CITY PLAN COMMISSION

FILE NUMBER: PLAT-25-000072 (S245-223) SENIOR PLANNER: Hema Sharma

LOCATION: Singleton Boulevard, at the terminus of Conroe Street

REQUEST: An application to replat a 3.4885-acre tract of land containing portion of City Block 7258 and a tract of land in City Block 7257 to create one lot on property located on Singleton Boulevard, at the terminus of Conroe Street.

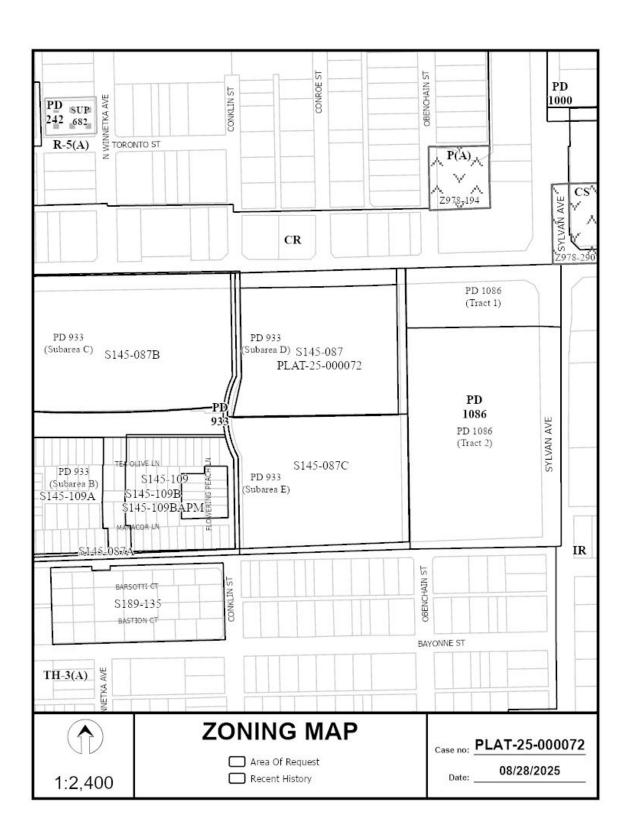
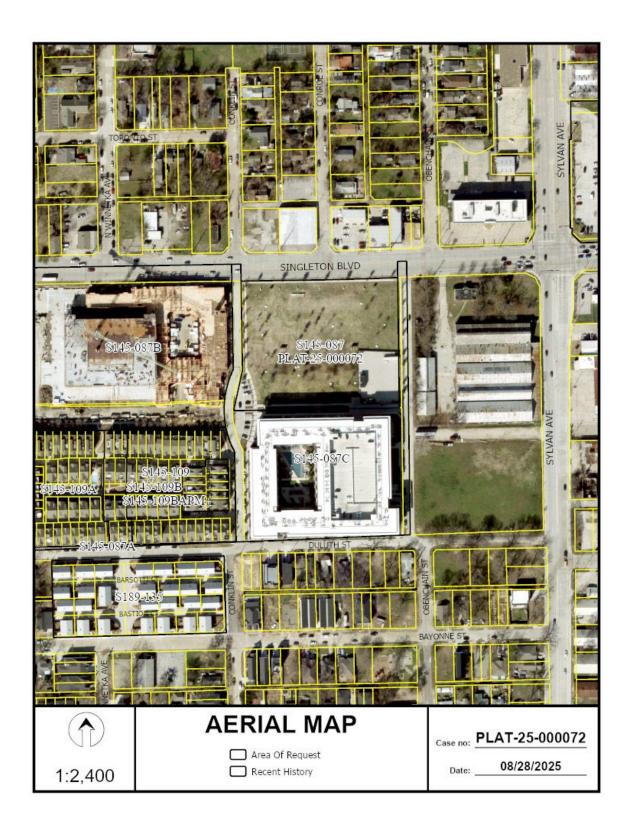
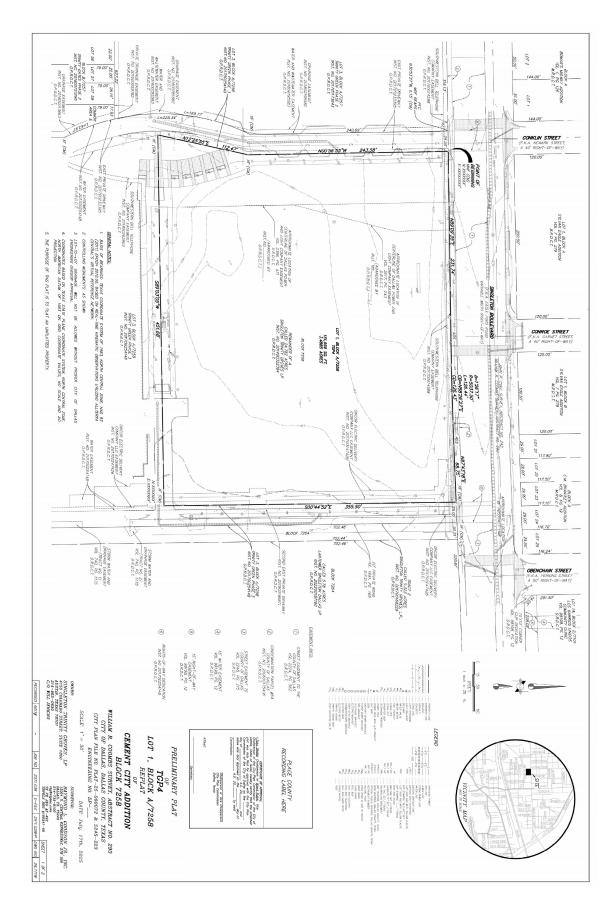
- 16. Prior to final plat, submit a completed final plat checklist and all supporting documents.
- 17. On the final plat, show how all adjoining right-of-way was created. Section 51A-8.403(a)(1)(A)(xxii).
- 18. On the final plat, show distances/width across all adjoining right-of-way
- 19. On the final plat, show recording information on all existing easements within 150 feet of the property.
- 20. On the final plat, move subdivision recording block to sheet 2 of two.

- 23. Prior to final plat, revised tree survey requested. The survey does not have to include trees under 8", but please assure that DBH measurements are correct for all protected trees(8" and up).
- 24. On the final plat, identify the property as Lot 1 in City Block B/7264.
